From: WJ Shack <wjshack@anl.gov>
To: Joe Muscara <JXM8@nrc.gov>
Date: Fri, Jun 16, 2000 8:47 AM
Subject: IP-2 NDE Problem

Subject/Message: IP-2 NDE Vugrafs (5/3/2000)

SG 24, R2C5 - 1997 Midrange +Point Data

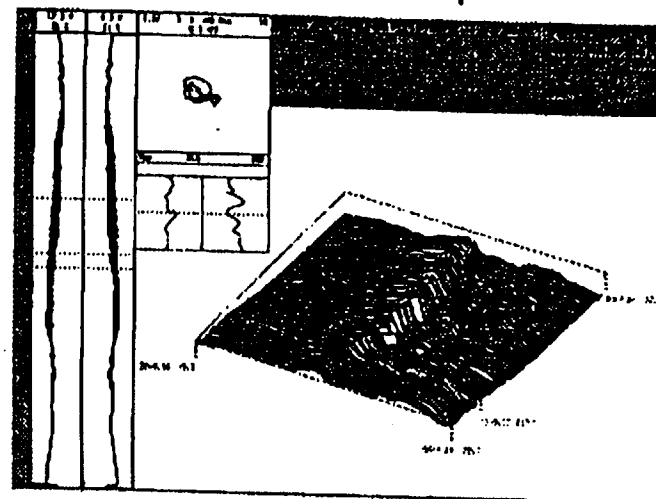
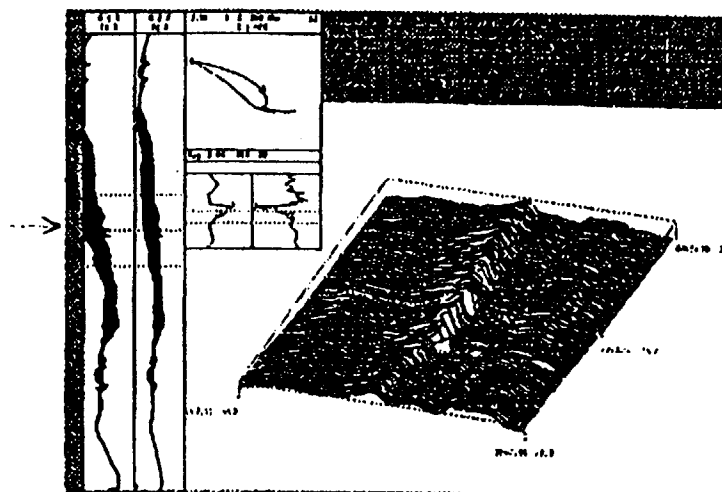
Viewgraphs 6 and 7 of the May 3, 2000 presentation by ConEd compare 1997 vs. 2000 setups applied to 1997 +Point U-Bend data (for R2C67 and R2C5). It appears that the purpose of this comparison is to show that the 2000 set up leads to R2C5 crack detection but not the 1997 setup and that both setups applied to R2C67 data reveal the crack clearly. Sasan and Dave have pointed out an apparent weakness in the ConEd explanation for why the R2C5 crack was missed. If you go to their viewgraph comparing the 1997 and 2000 setups (Slide 7 attached), they are suggesting that the difference in setup makes a big difference in the resulting Lissajous figure, and hence in the decision as to whether or not there is a crack. However, in slide 7 (R2C5) they are not examining the Lissajous figure at the same axial location whereas they are in slide 6 (R2C67). Note that the 2000 signal is analyzed at the location of the two (very small) signal blips, whereas the 1997 signal is analyzed at a different location. Sasan says that when he analyzes the data using the 1997 and 2000 setups, there is very little difference in the Lissajous figures when he takes them at the same location. Give Dave or Sasan a call to discuss further.
